SUBMITTAL OF HANFORD FACILITY RESOURCE CONSERVATION AND RECOVERY ACT (RCRA) PERMIT MODIFICATION NOTIFICATION FORM 24590-PTF-PCN-ENV-09-012

Hanford Facility RCRA Permit Modification Notification  
Form 24590-PTF-PCN-ENV-09-012

Page 2 of 3: Hanford Facility RCRA Permit, Part III, Operating Unit 10, Waste Treatment and Immobilization Plant  
Replace Piping and Instrumentation Diagrams (P&ID) for the PTF Pulse Jet Ventilation (PJV) System and  
Vessel Vent Process (PVP) System in Appendix 8.2 of the Dangerous Waste Permit.

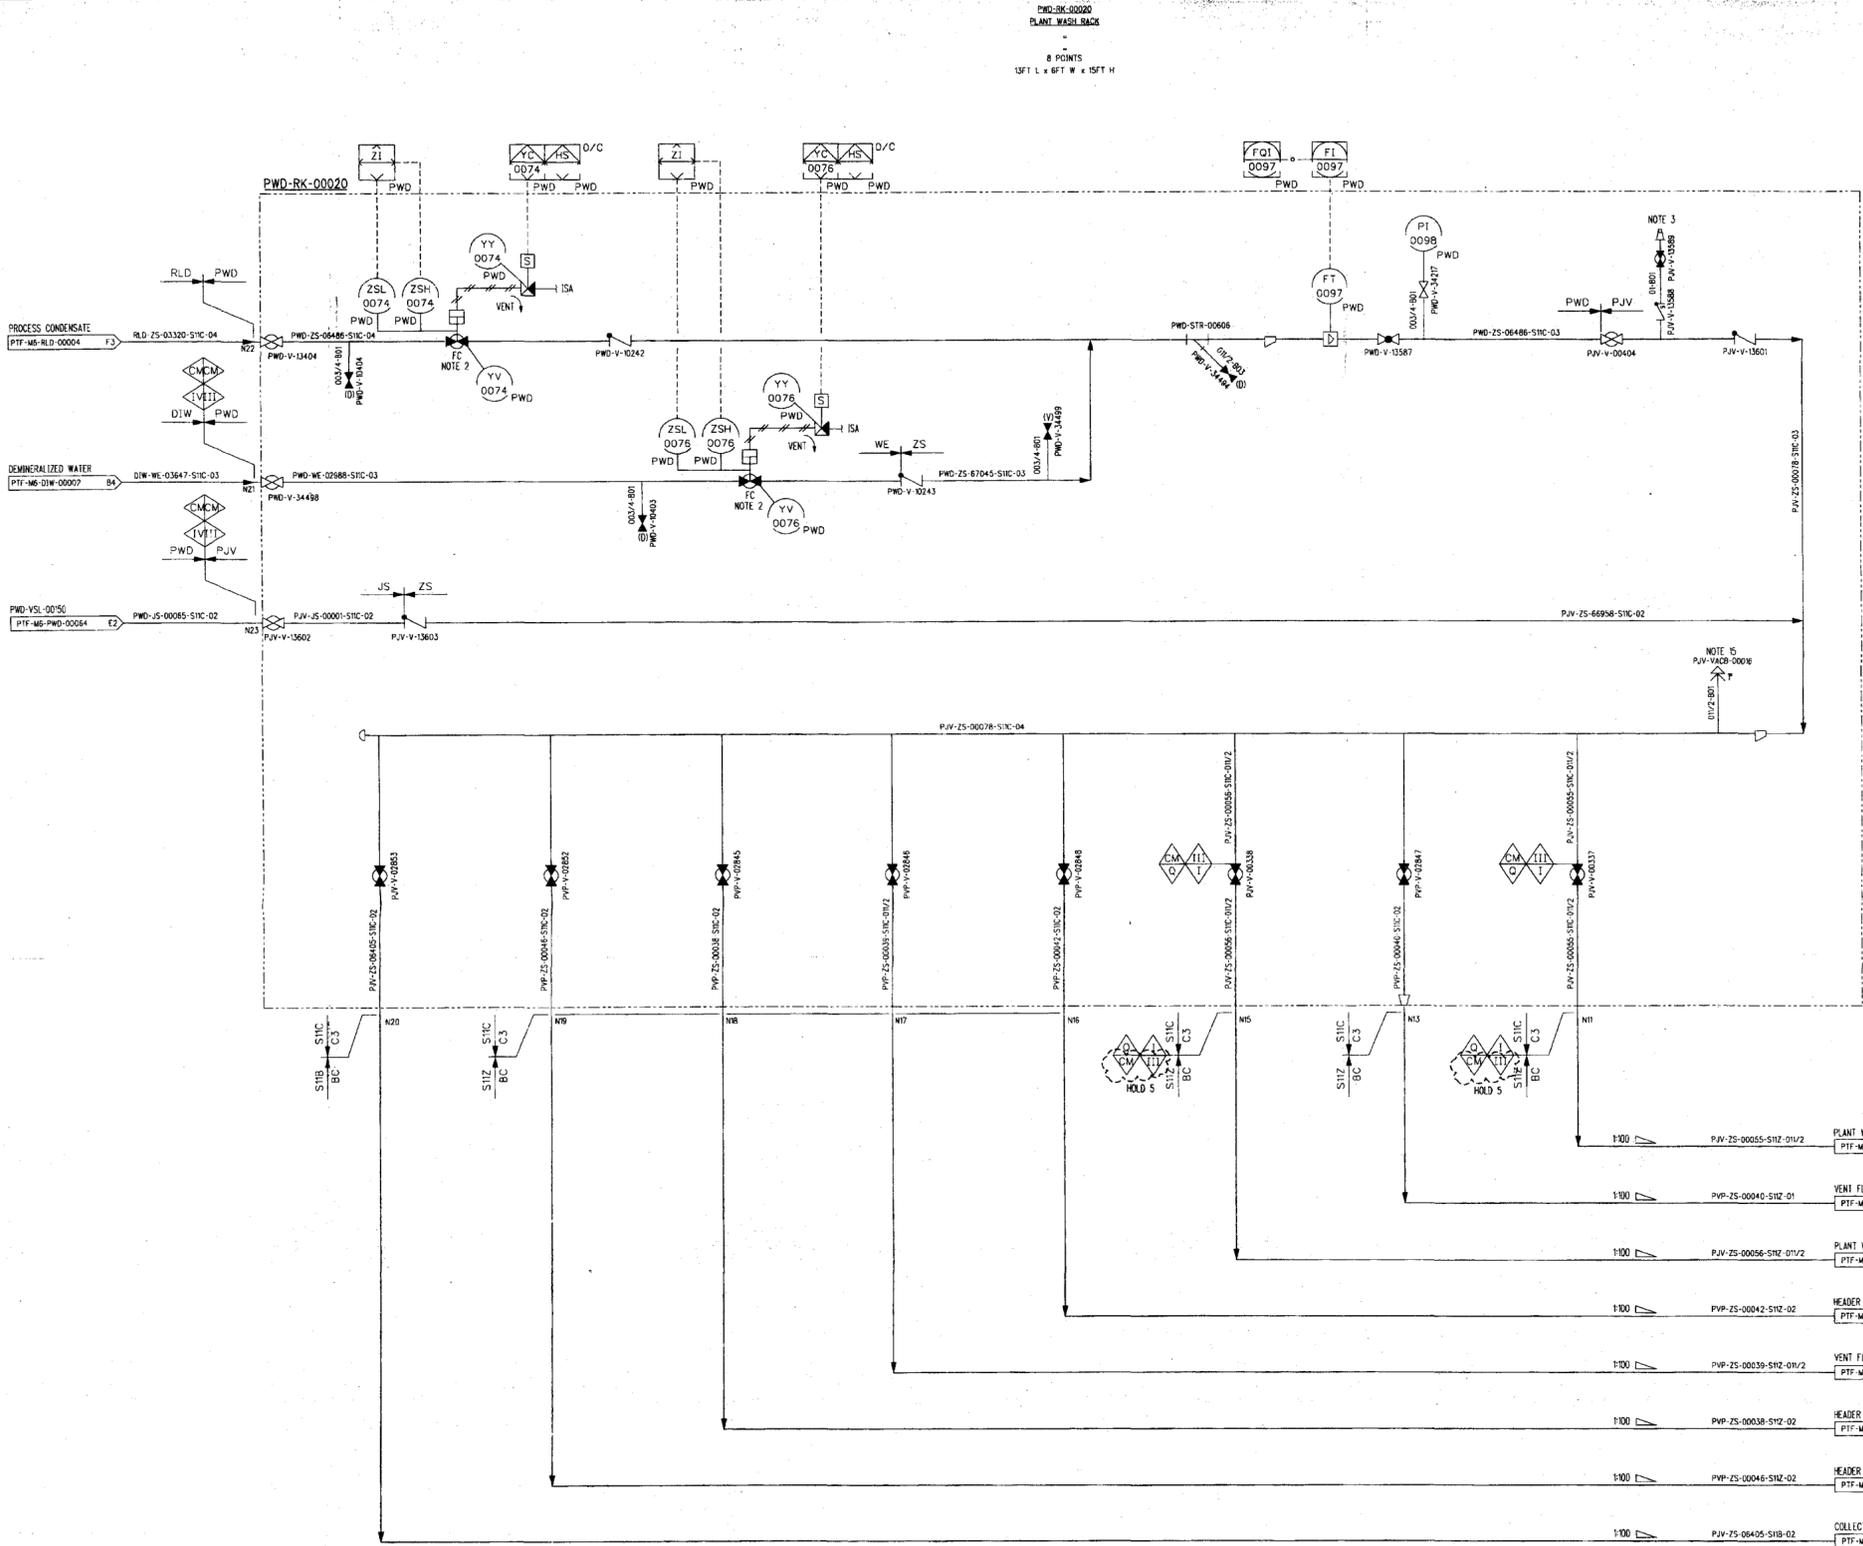
- BRANCH TO BE CONNECTED TO HORIZONTAL RUN OF HEADER PIPE.
- REVISION 3: MAJOR REVISION NO REVISION CLOUDS REQUIRED. REVISED TO INCORPORATE 24590-PTF-M6-PJV-00031, DELETED VACUUM BREAKERS FROM INDIVIDUAL WASH LINES AND ADDED VACUUM BREAKER TO MAIN HEADER, ADDED CHEMICAL INJECTION LINE AND VALVES, UPDATED OFF SHEET CONNECTIONS, REVISED/ADDED/DELETED NOTES, HOLDS, AND REFERENCES, UPDATED SEISMIC CATEGORIES AND QUALITY LEVELS OF WASH LINES, REVISED LAYOUT TO MEET DRAFTING STANDARDS.

DRAWING INDEX	
DWG NO	TITLE
24590-PTF-M6-PVP-00004001	PVP SYSTEM VOC OXIDATION UNIT FAN
24590-PTF-M6-PVP-00004002	PVP SYSTEM CARBON BED ADSORBERS

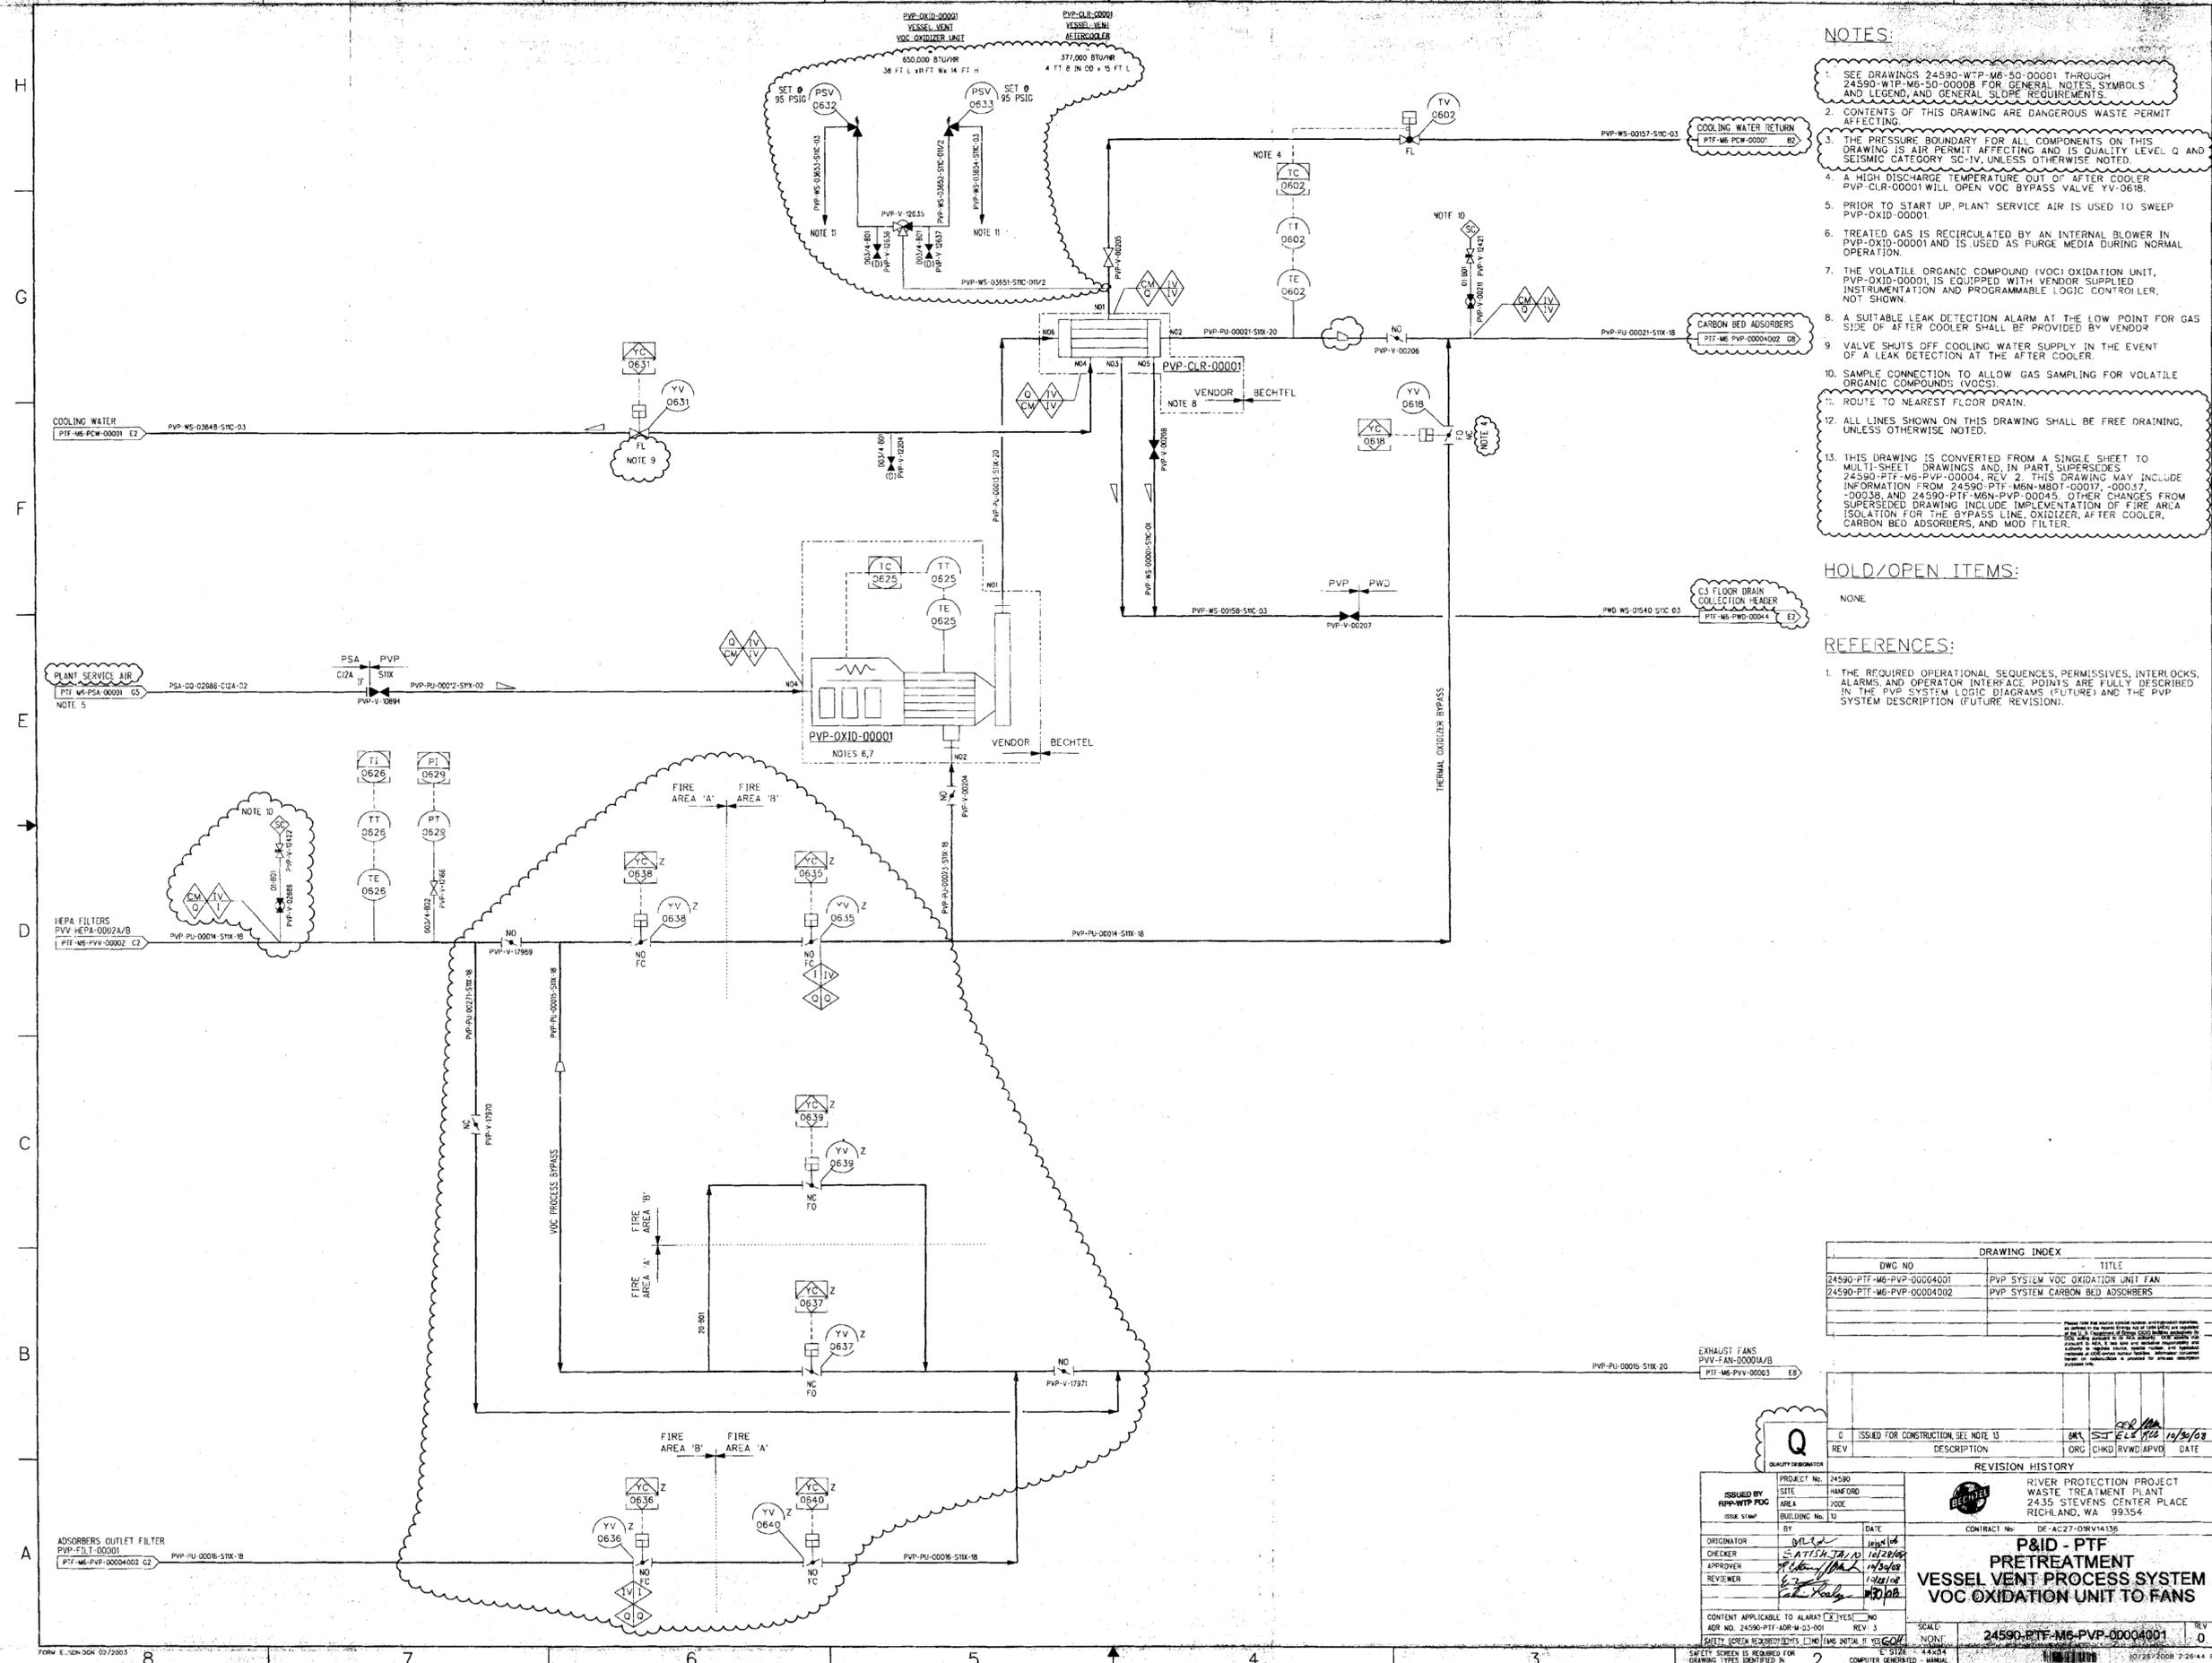
- THIS DRAWING IS CONVERTED FROM A SINGLE SHEET TO MULTI-SHEET DRAWINGS AND, IN PART, SUPERSEDES 24590-PTF-M6-PVP-00004, REV 2. THIS DRAWING MAY INCLUDE INFORMATION FROM 24590-PTF-M6-M601-00017, -00037, -00038, AND 24590-PTF-M6-PVP-00045. OTHER CHANGES FROM SUPERSEDED DRAWING INCLUDE IMPLEMENTATION OF FIRE AREA ISOLATION FOR THE BYPASS LINE, OXIDIZER, AFTER COOLER, CARBON BED ADSORBERS, AND MOD FILTER.

**P&ID - PTF  
 PRETREATMENT  
 VESSEL VENT PROCESS SYSTEM  
 CARBON BED ADSORBERS**

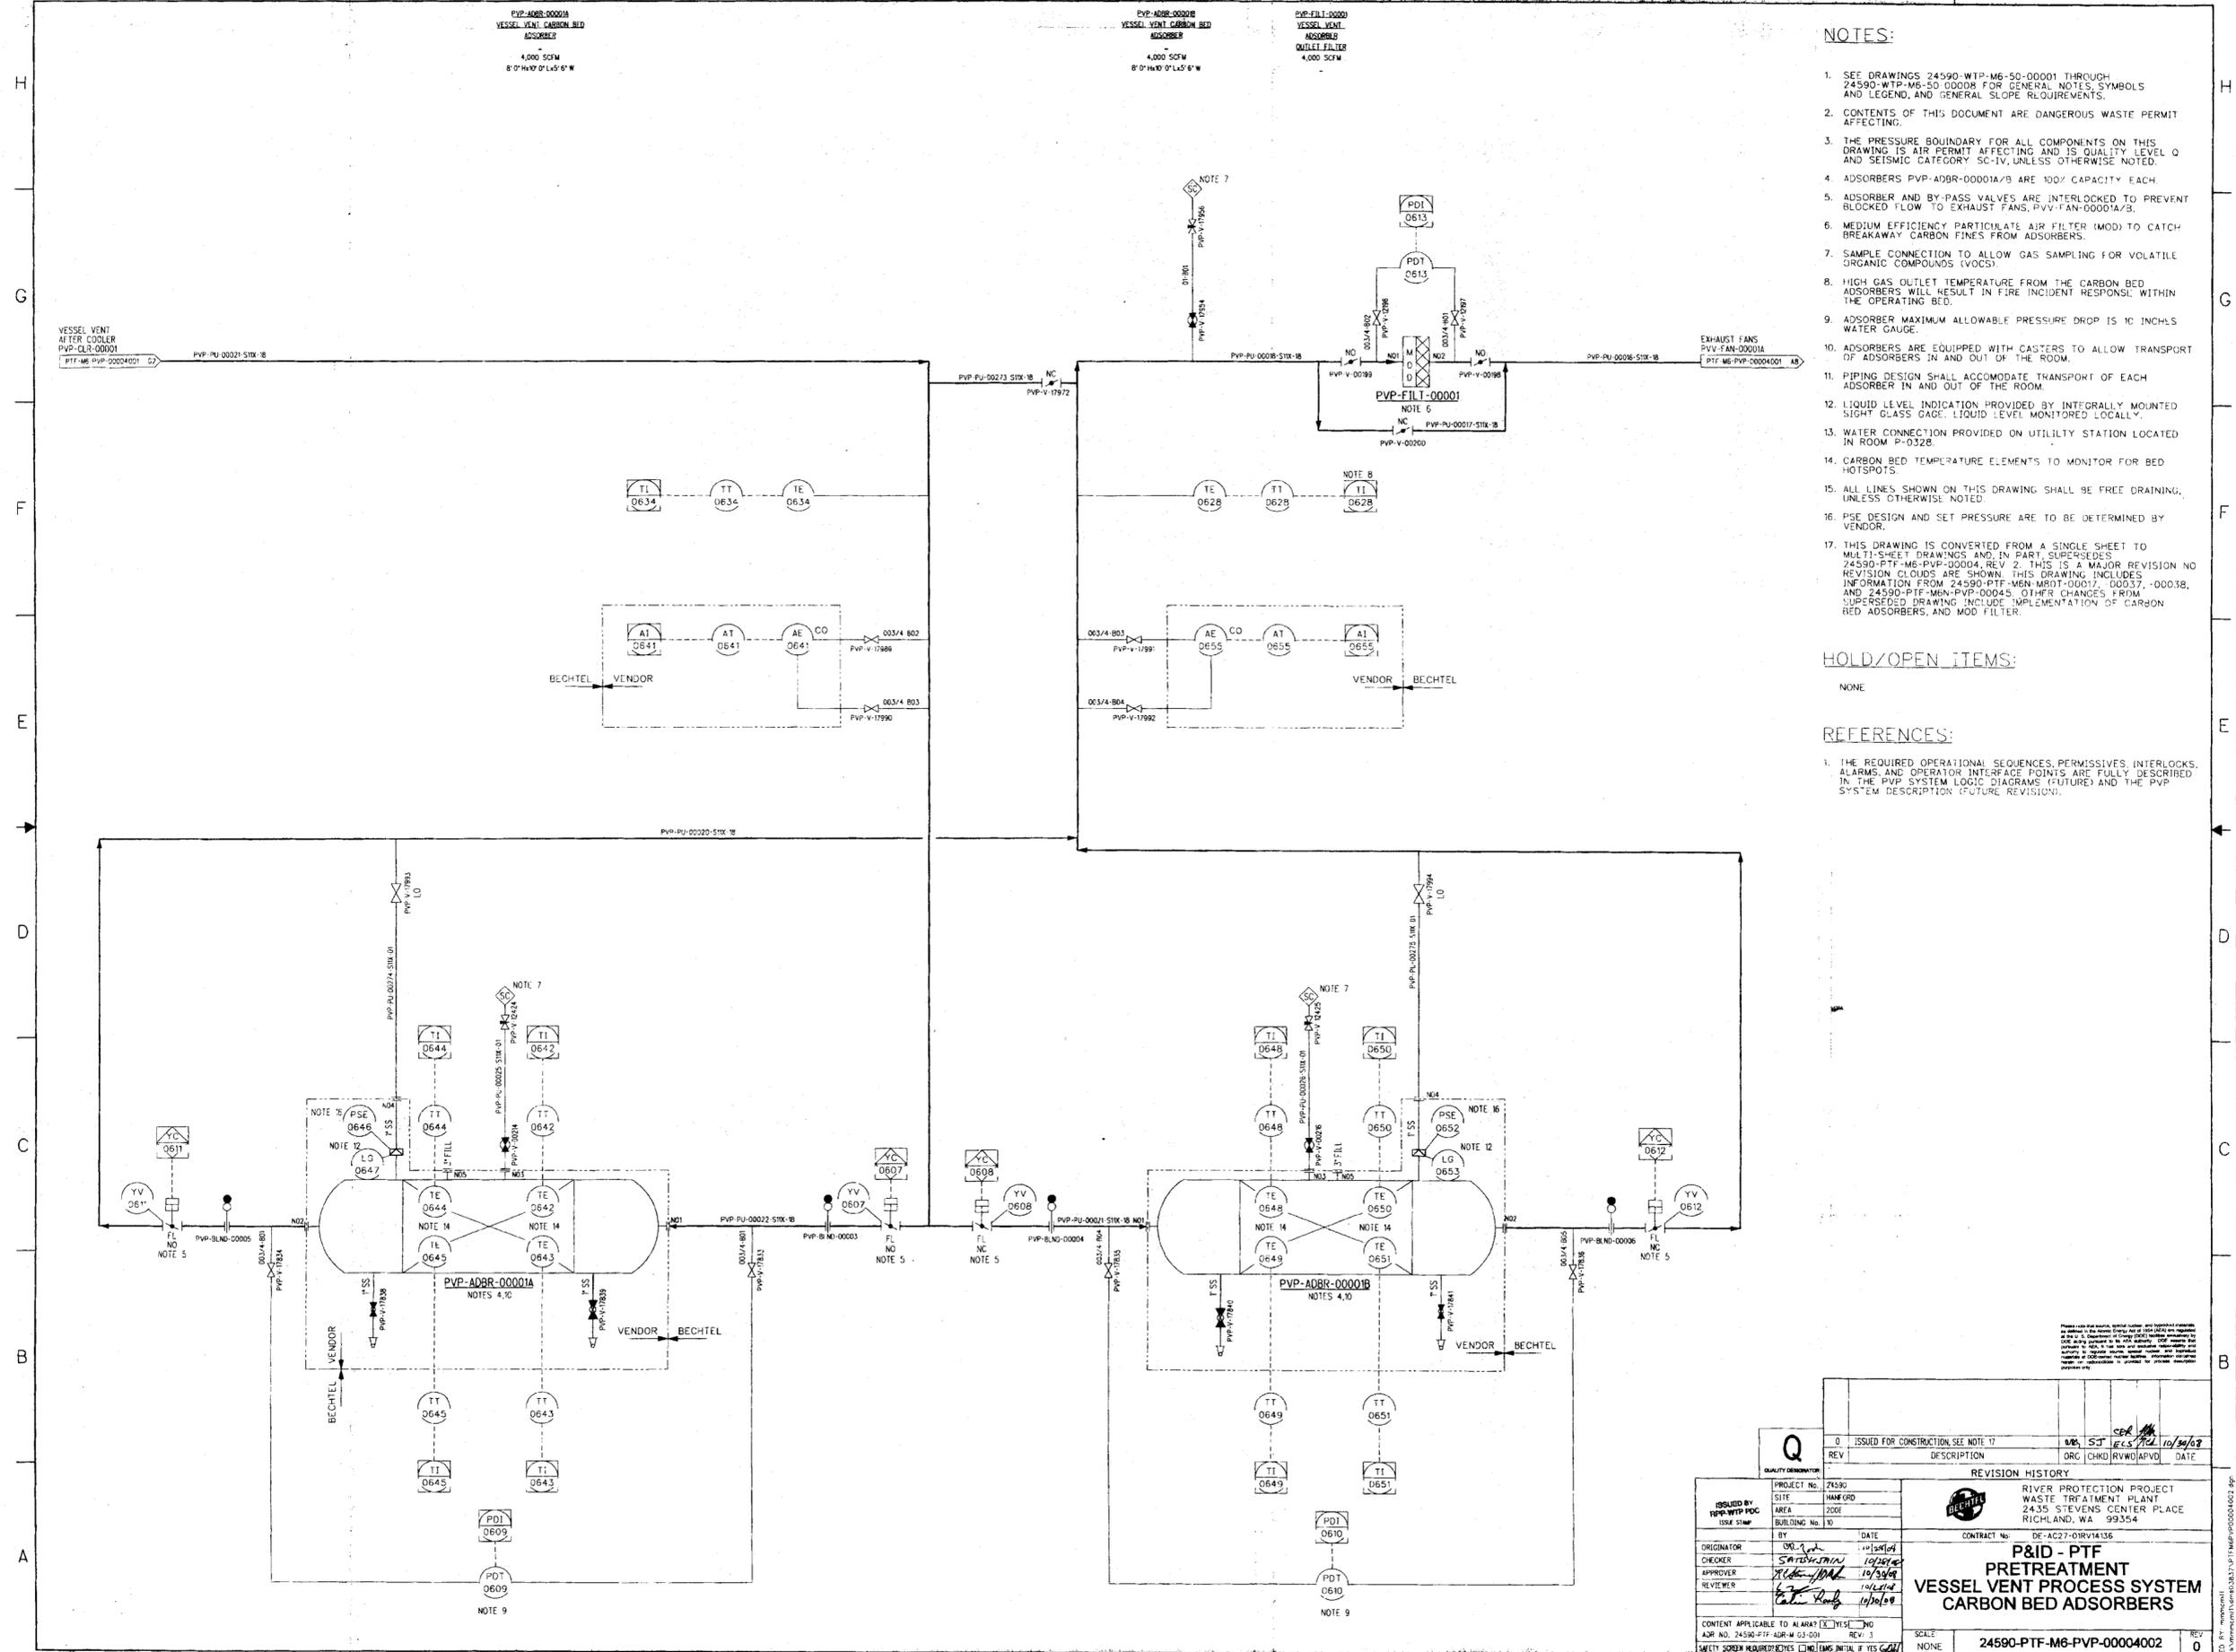
- THIS DRAWING IS CONVERTED FROM A SINGLE SHEET TO MULTI-SHEET DRAWINGS AND IN PART SUPERSEDES 24590-PTF-M6-PVP-00004, REV. 2. THIS IS A MAJOR REVISION NO. REVISION CLOUDS ARE SHOWN. THIS DRAWING INCLUDES INFORMATION FROM 24590-PTF-M6N-M601-00017, 00037, 00038, AND 24590-PTF-M6N-PVP-00045. OTHER CHANGES FROM SUPERSEDED DRAWING INCLUDE IMPLEMENTATION OF CARBON BED ADSORBERS, AND MOD FILTER.
